**TECHNICAL CIRCULAR No. RDSO/2010/EL/TC/0106 (Rev. '0'),**  
**Dated 11.10.2010**

**Sub: Problem of excessive ramp up time of 180kVA SIV.**

## Annexure-1

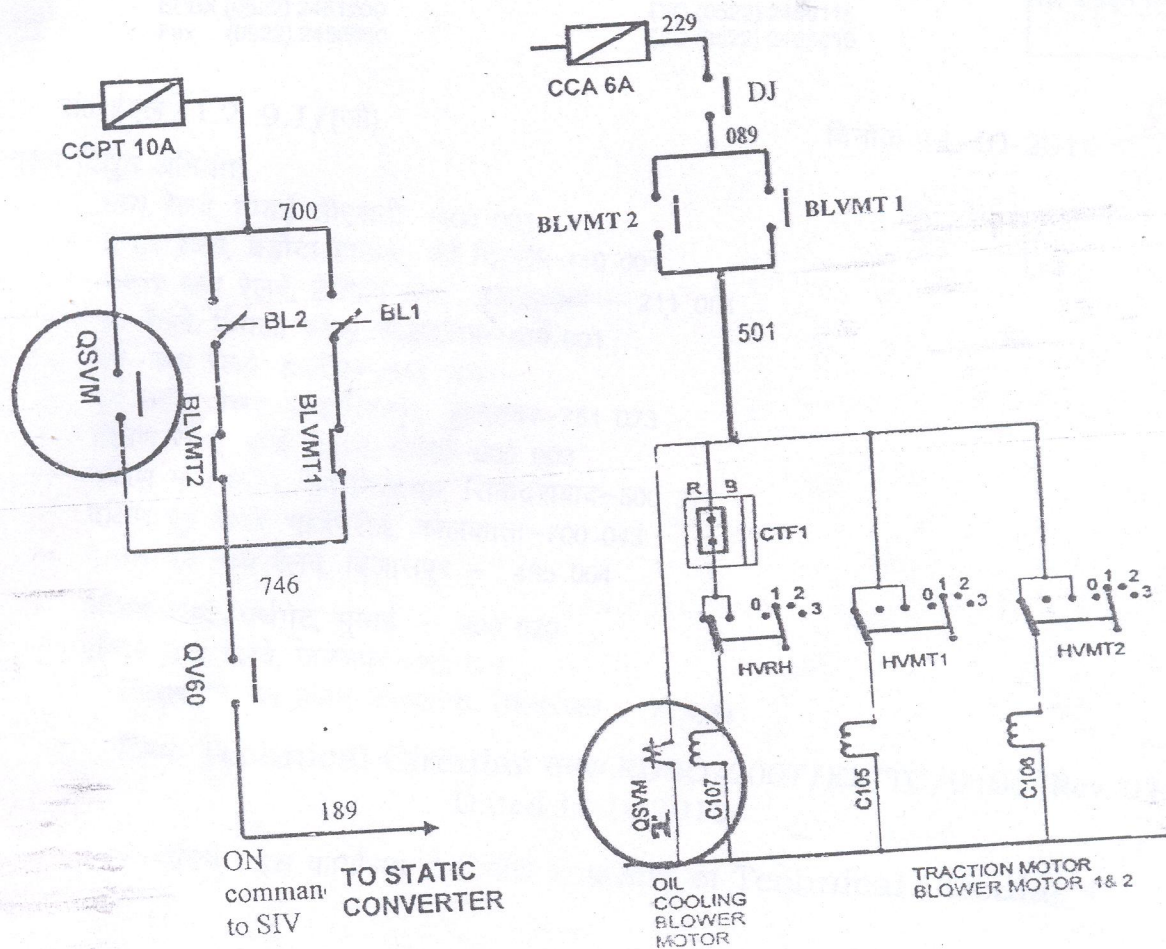
- iii. In regard to SIV ramp up time it may be noted that the total ramp up time (from pressing of BLRDJ to LSCHBA lamp off) also includes the on time delay of QSVM in addition to the ramp up time of SIV. It may also be noted that SIV gets ON command only after pick of QSVM relay as per circuit attached as Annexure-1. It is noticed that the time delay of QSVM relay provided in the software of MPCs is 5 sec. as against 2 sec. stipulated in RDSO Modification Sheet no. ELRS/MS/0335, Rev. '0' dated 28.01.2005. Hence after pressing the BLDJ & BLRDJ, the ON command to SIV will pass only after 5 sec. due to 5 sec. ON time delay of QSVM, which is causing delay in the ramp up of SIV.

After switching on the BLVMT, ON command at SIV will pass only when QSVM relay picks up & NO interlock of QSVM relay change it's position to close interlock.

- iv. The issue has been taken up with the manufacturers of MPCs and all the manufactures of MPCs have been advised vide this office letter no EL/4.2.15 dated 30.09.2010 to modify the software to reduce the time delay from 5 sec. to 2 sec. ON-time delay as stipulated in RDSO Modification Sheet. This will reduce the total ramp up time (from BLRDJ switch on to LSCHBA lamp off) by 3 sec. Trial of modified MPCs software has been jointly conducted at ELS/CNB on 23.09.2010 with M/s Medha, M/s AAL & M/s Siemens. During the trial it was found that the total ramp up time of SIV (from pressing BLRDJ to LSCHBA switch OFF) is around 17 sec. with modified FDCS during initial charging of locomotive (with DC link voltage as 0 volt). During the running of locomotive if DJ trips because of any reason / in the neutral section and loco pilot switches on BLDJ and BLRDJ, in that condition, total ramp- up time will be less than 15 sec. as rectifier section of SIV takes less time due to availability of residual DC link voltage.

In view of above, it is advised to get the software of MPCs modified by the manufactures and also in relay based locomotive, setting of QSVM relay

is to be ensured as 2 sec. ON-time delay. Loco pilots may also be counseled to take notch only when LSCHBA lamp extinguishes, otherwise first notch tripping will take place.
